ADDENDUM NUMBER TWO

**USC Women's Basketball Offices and Team Spaces
Project No.: U-787-14-6**

State Permanent Improvement Project No.: H27-Z196

DATE OF ISSUE: March 27, 2015

Drawing No. **M1.1**

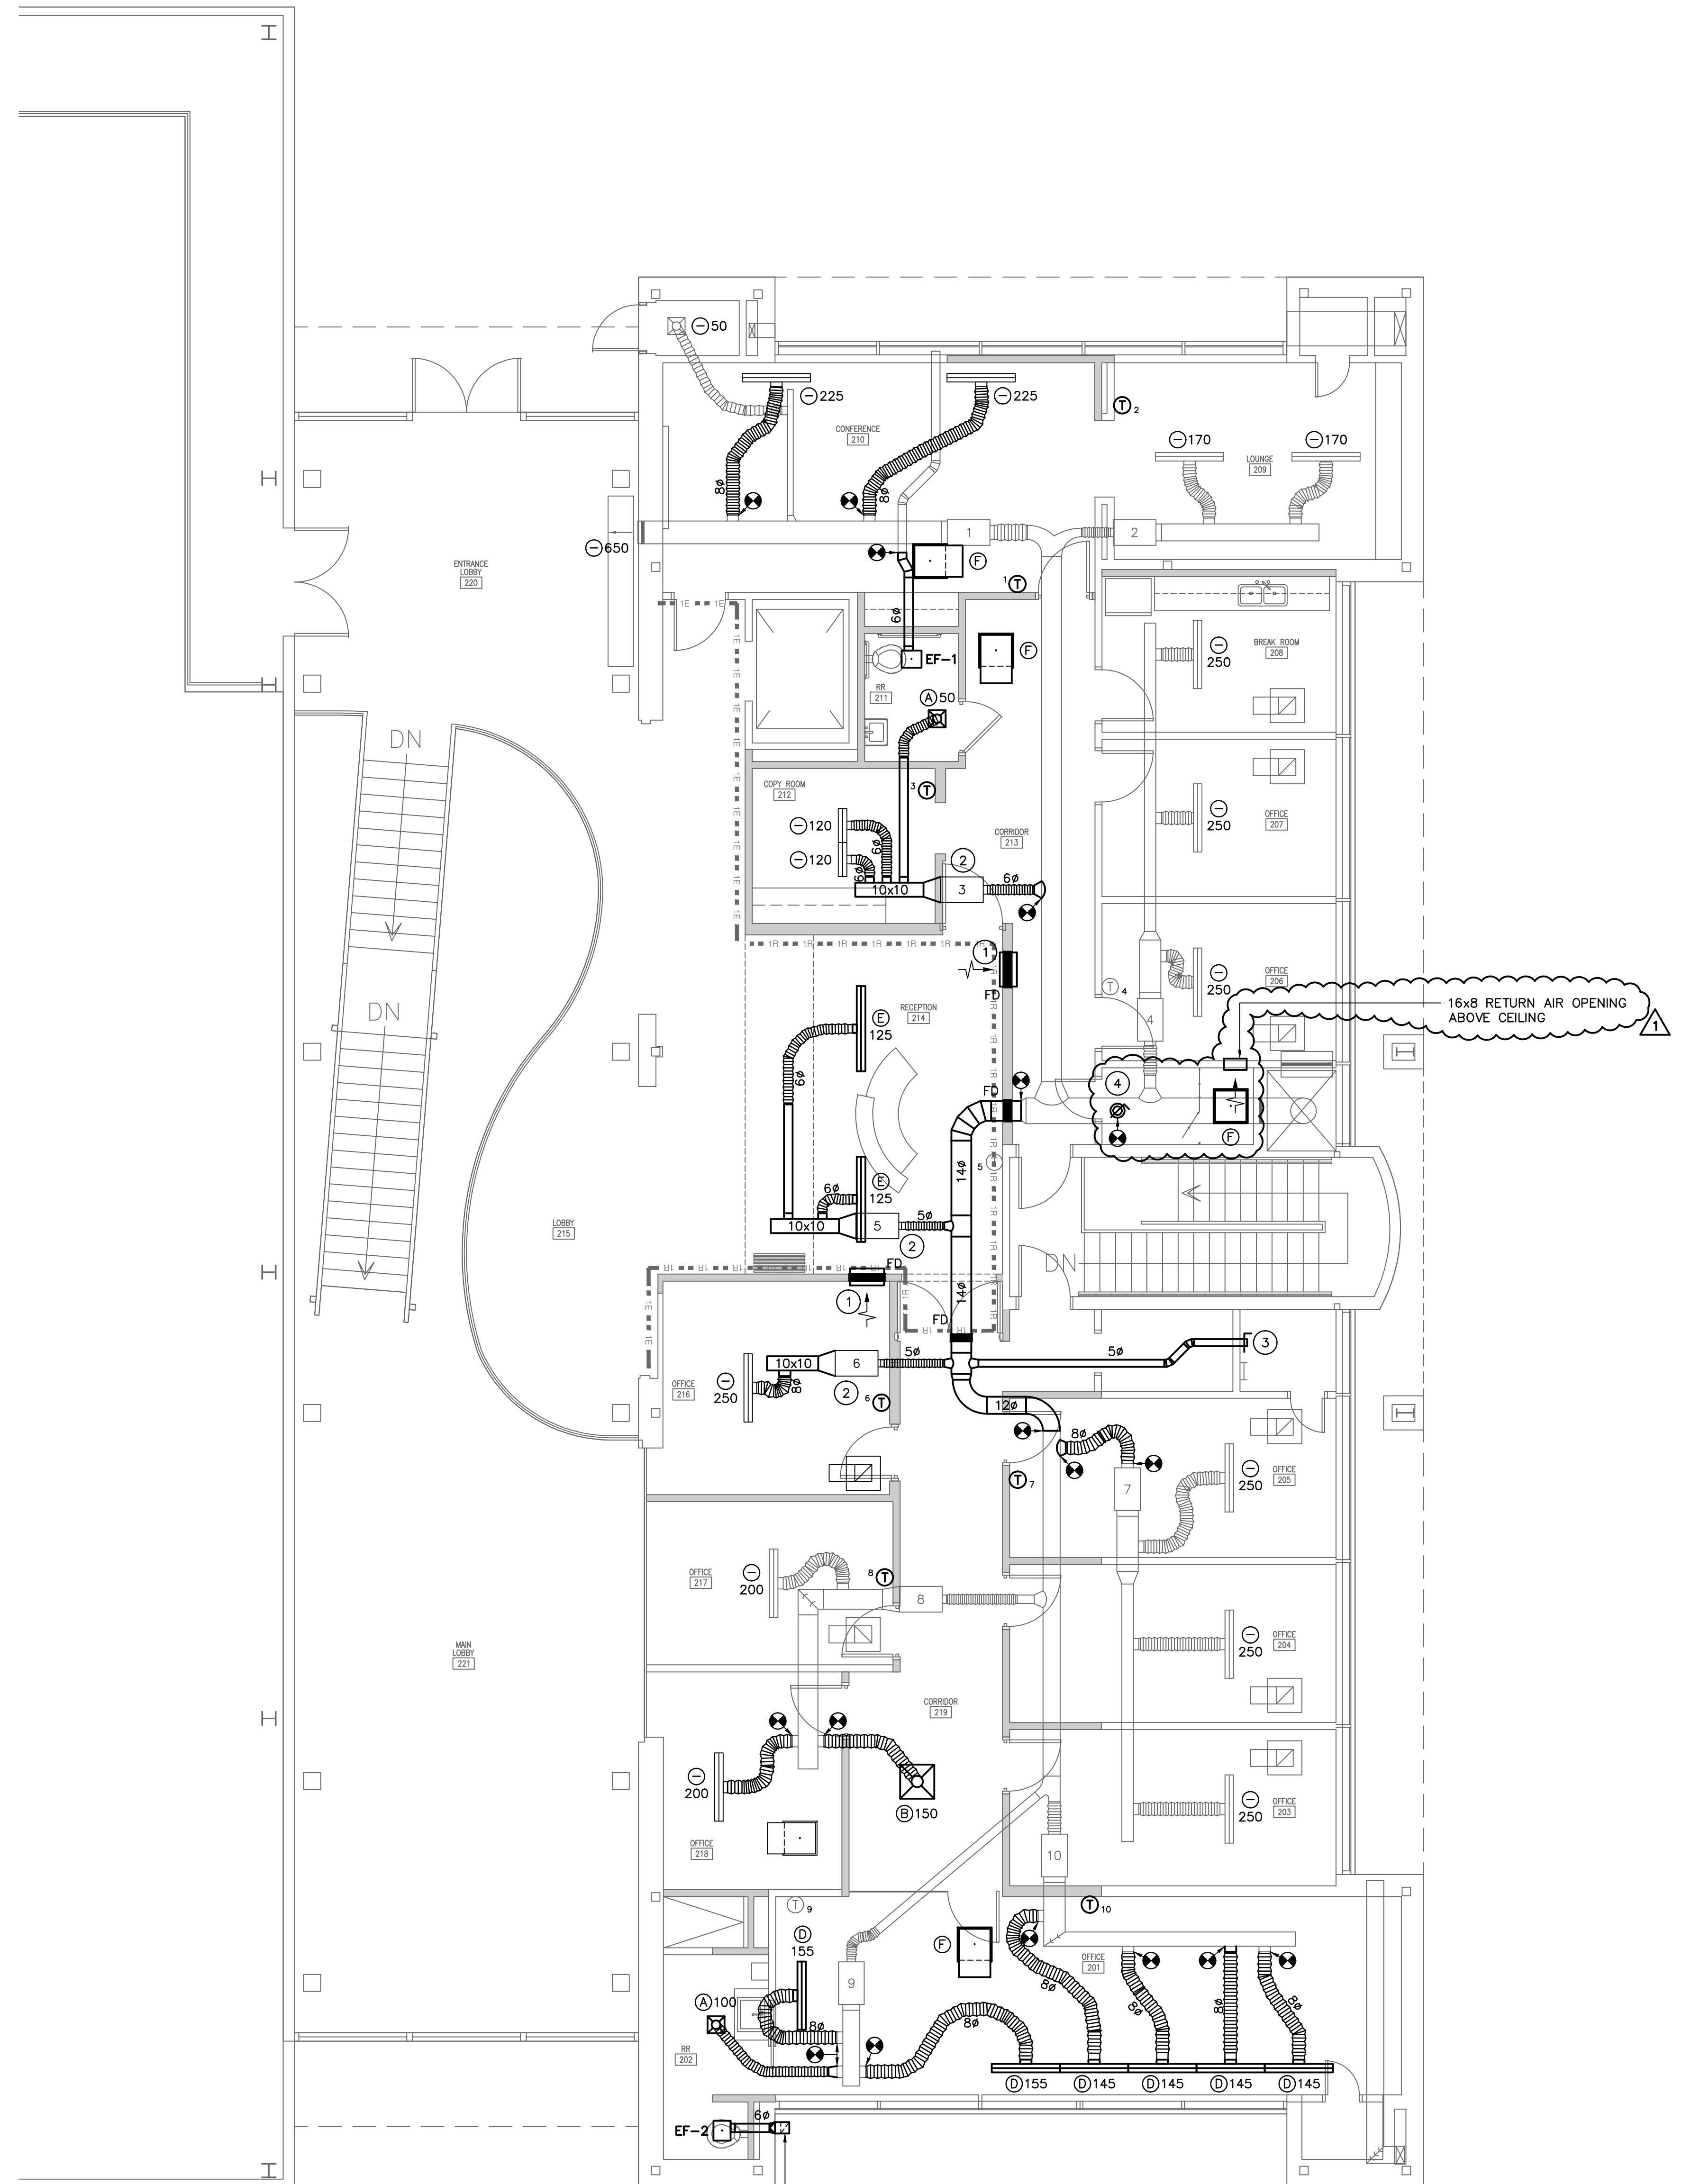
<u>Item No.</u>	<u>Description</u>
1.	<u>Revision:</u> Reference Drawing M1.1_R1: Added medium pressure duct takeoff, low leakage manual damper, return grille, and return air transfer to the Elec/Comm Closet between Office 206 and the Stair
2.	<u>Revision:</u> Reference Drawing M1.1_R1: Renovation Note 3 was modified and Renovation Note 4 was added.

- 1 24x18 RETURN AIR OPENING ABOVE CEILING WITH FIRE DAMPER.
- 2 RELOCATED VAV BOX. EXTEND HOT WATER SUPPLY AND RETURN AS REQUIRED. FIRE SEAL ALL HOT SUPPLY AND RETURN PIPE PENETRATIONS AT FIRE RATED PARTITION.
- 3 EXTEND MEDIUM PRESSURE SPIRAL DUCT THROUGH WALL AND TERMINATE WITH LOW LEAKAGE MANUAL DAMPER EQUAL TO GREENHECK MODEL VCDR-53 WITH LOCKING HAND QUADRANT.
- 4 EXTEND 8"Ø MEDIUM PRESSURE SPIRAL DUCT DOWN THROUGH EXISTING CEILING AND TERMINATE WITH LOW LEAKAGE MANUAL DAMPER EQUAL TO GREENHECK MODEL VCDR-53 WITH LOCKING HAND QUADRANT.

PROVIDE 8"x6" PRICE MODEL 630, OR APPROVED EQUAL, ALUMINUM SOFFIT GRILLE
